ADDENDUM NO. 1

April 14, 2022

YOST ELEMENTARY SCHOOL ADDITIONS AND RENOVATIONS Chesterton, IN 46304

Addendum One (AD.01) to the drawings and specifications prepared by Gibraltar Design for **New Yost Elementary School** for Duneland School Corporation, Chesterton, Indiana.

2
A-417

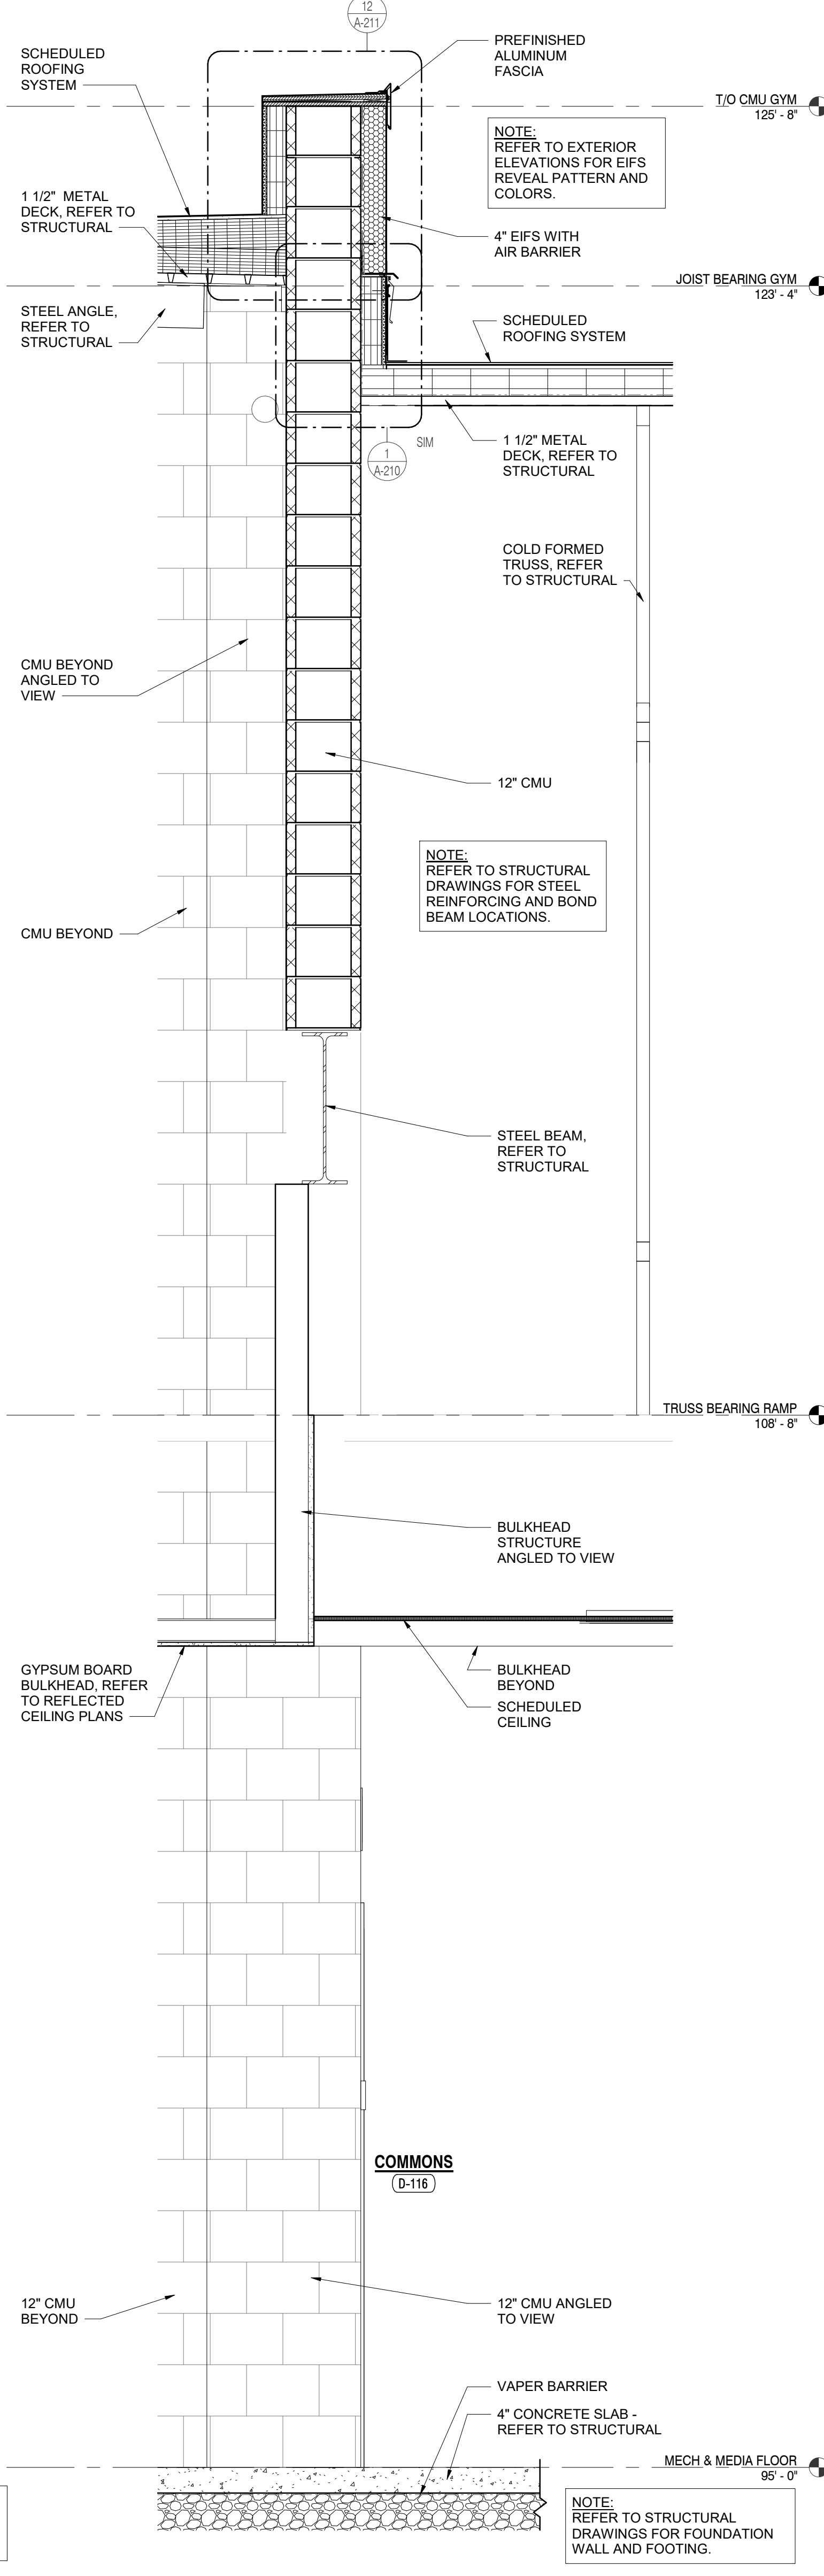
16. Sheet A-417

- A. Refer to revised full size drawing, included in this Addendum, for the following revisions:
 - 1. Wall Section 2/A-417: Revise graphics of door frame and wall beyond to match plan detail.

2 WALL SECTION

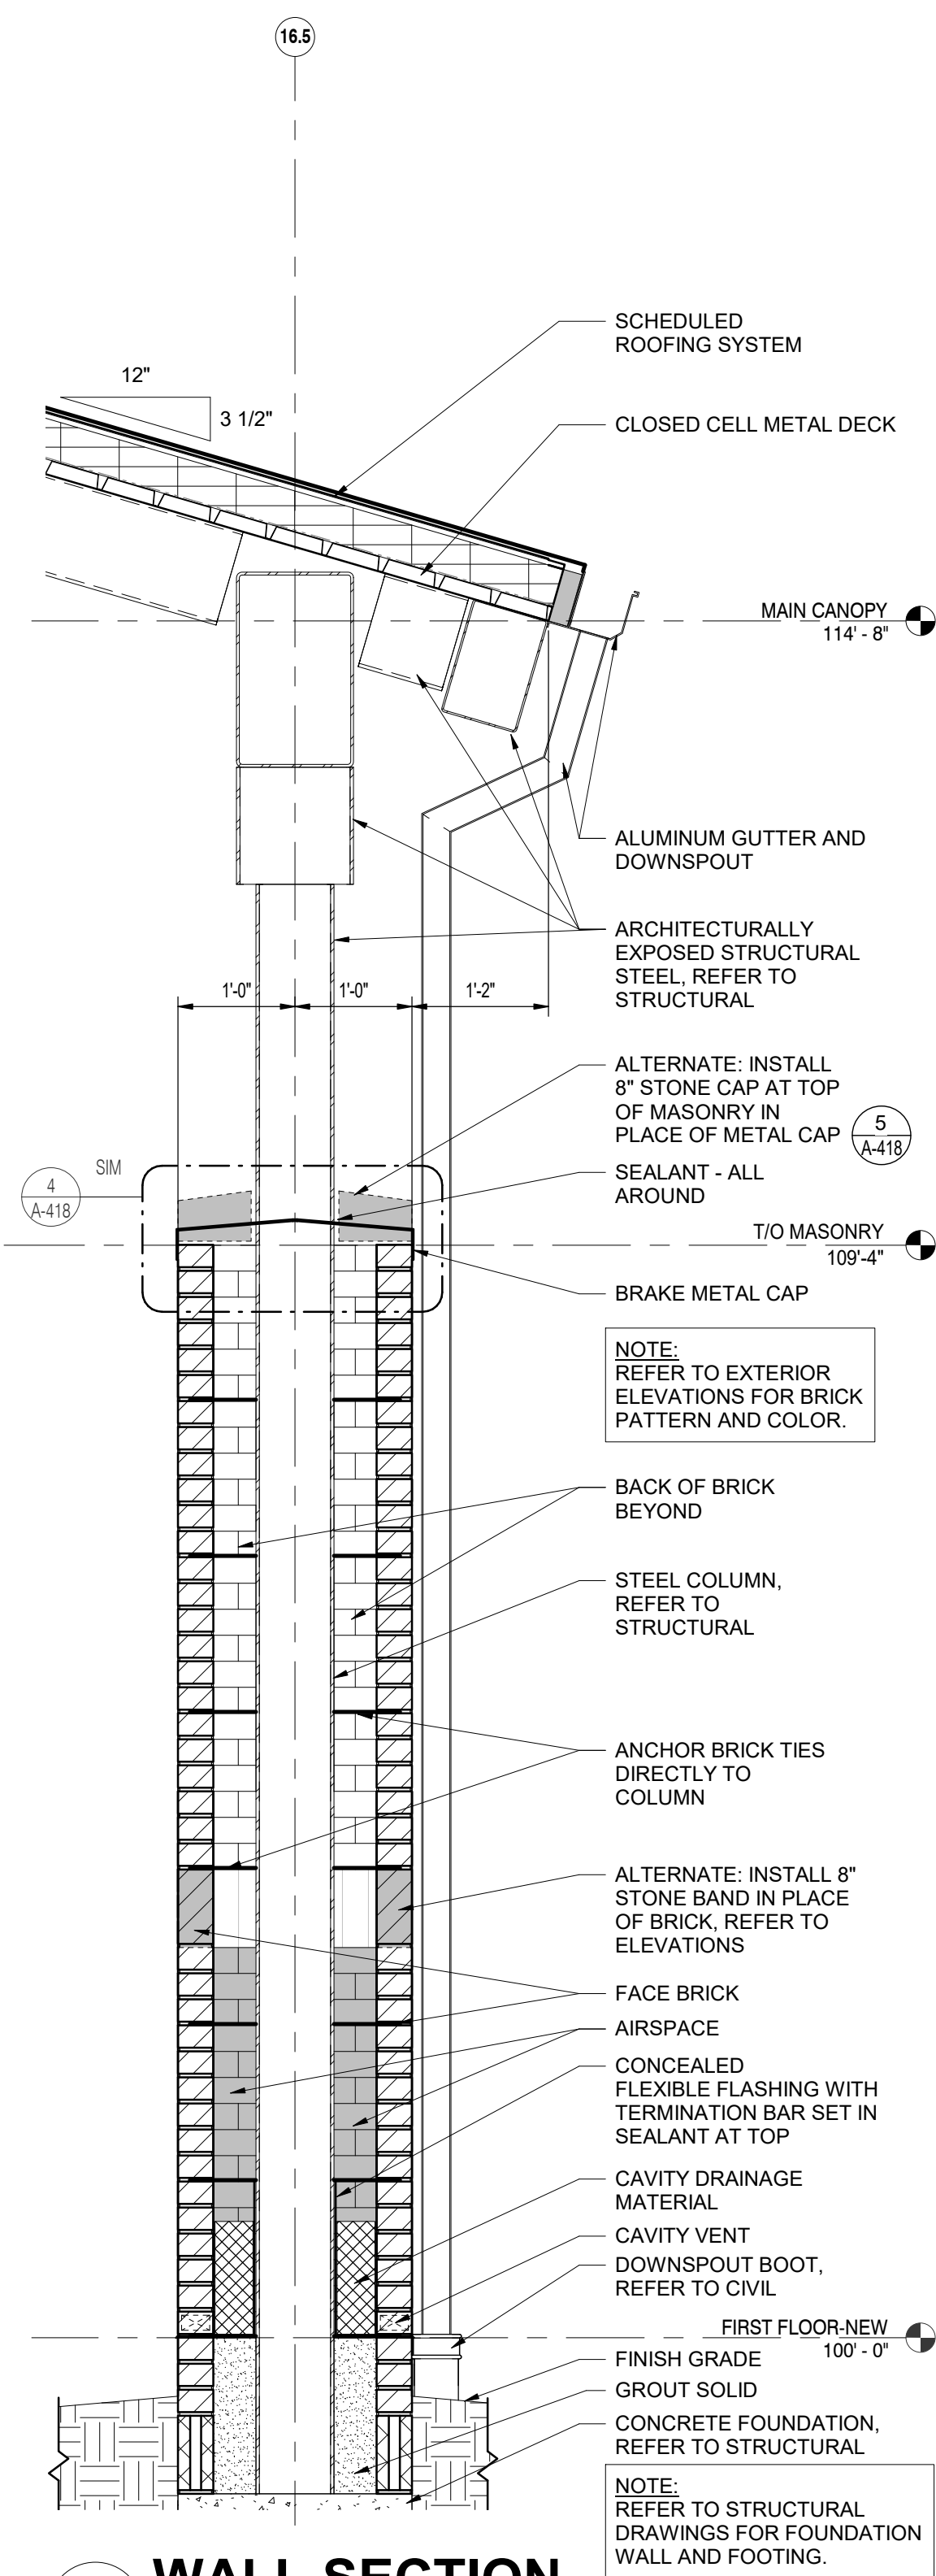
17. Sheet A-418

- A. Refer to revised full size drawing, included in this Addendum, for the following revisions:
 - 1. Wall Section 2/A-418: Remove reference to Section 1/X100 not included in Construction Documents.
